Streetscape Trees along NE 2nd Ave and NE 2nd Street, and 2nd Floor Planters

Landscape Changes:

CLASS II APPLICATION June 14, 2021

CLASS II APPLCATION MODIFICATION Re14 2021	MENIN
	$-\rho$
	RAV
	233 NE 2nd Avenue Delray Beach, FL 33444
	Class II Site Plan Modification 06.14.202}
	Gorzález Archilects Hospitality
	;
EZ ARCHITECTS EX VENUE, EUITE 507 33132 ID AVENUE BEACH, FL 33444 LDING 2017 IMBING 2017 ISSSIBILITY 2017 STANICAL 2017 C) 2014 DDE - 7TH EDITION 2018 ISSCOLATION (NFPA) 2015 Ida FFPC 6th AMENDMENTS IBLE DESIGN 2010	North Adams
59'-10" 5 LEVELS ABOVE GRADE 2 LEVELS BELOW GRADE (GARAGE) R-1 (HOTEL) M (RETAIL), A-2 (DINING), A-2 (MEETING ROOMS), S-2 (STORAGE) I B CBD (CENTRAL BUSINESS DISTRICT) YES 202,272 sq.ft.	Drawing life Index sheet and Vicinity Map Scole Articles Dece Articles Dece Articles
200,272 squit.	naket No. 1974 Drowing No. T1.01

PREVIOUSLY APPROVED SPRAB PLANTING PLAN

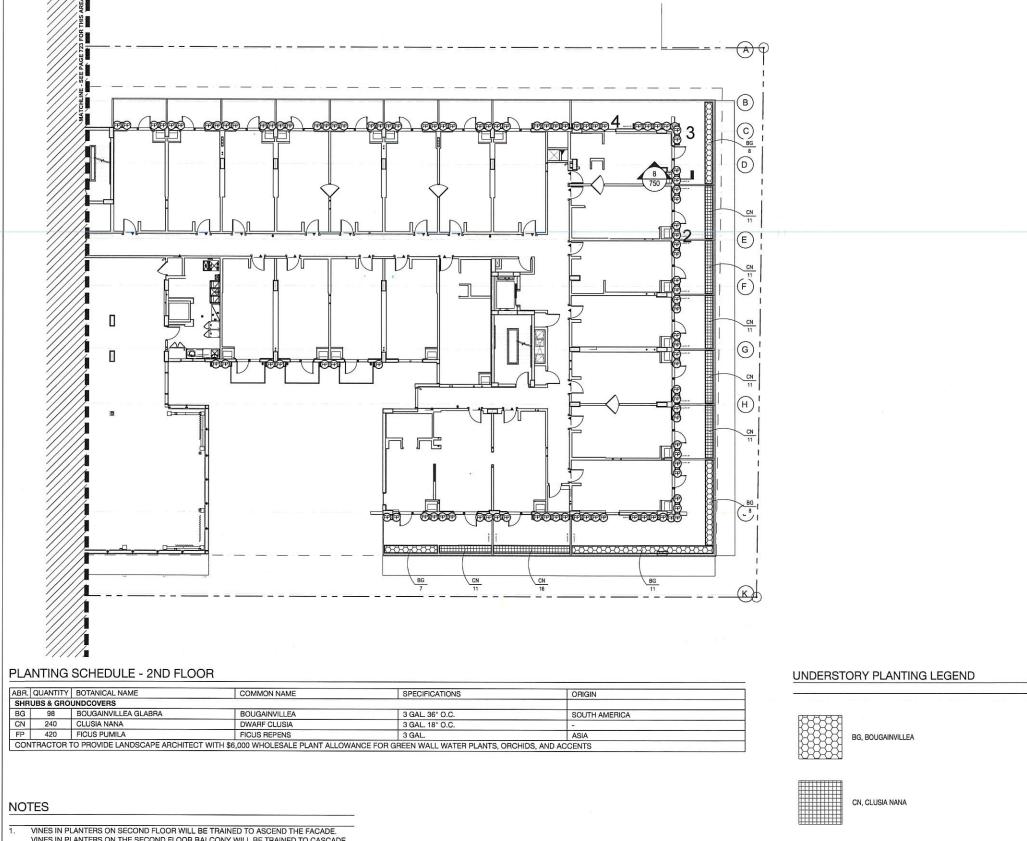
VINES IN PLANTERS ON SECOND FLOOR WILL BE TRAINED TO ASCEND THE FACADE.
 VINES IN PLANTERS ON THE SECOND FLOOR BALCONY WILL BE TRAINED TO CASCADE DOWN THE FACADE.

PROPOSED SHRUB / VINES
